## **Access Statement**

**Re:** Revised Adaptable Units

**Project:** Mixed Use Retail and Residential Development

**Address:** 332-338 Sydney Road, Balgowlah NSW

*Screenshot of pre and post adaptation units prepared by Wolski Coppin Architecture*

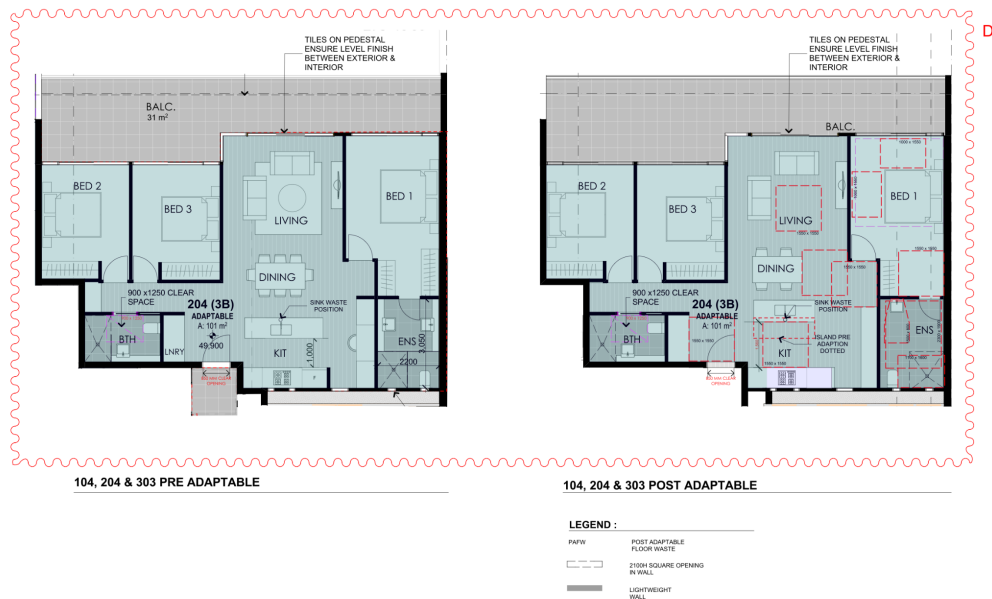
It is my professional opinion that the revised adaptable unit layouts has the capacity to satisfy the following adaptable and visitable housing design requirements, as follows:

1. Drawings - 3 units to be adaptable in accordance with Class C AS4299 Adaptable Housing (1995).
2. Siting - level access from street frontage and level access is proposed from basement car parking areas to each Adaptable Unit as well as access to common use facilities.
3. Security - potential for pathway lighting to be 50 lx and safe vehicle drop off point.
4. Private Car Accommodation - Basement car parking provided for the three (3) adaptable units
5. Accessible 850mm clear entry to the adaptable units.
6. Interior General - Minimum door width 820mm, internal corridors 1000mm.

7. Living room and dining room circulation space, GPO's and telephone outlets.
8. Adaptable Kitchen
9. Main Bedroom circulation space and GPO's
10. Bathroom
11. Toilet to be visitable
12. Laundry
13. Door Locks 900 - 1100mm height
14. Non-slip floor coverings to outside balcony areas.
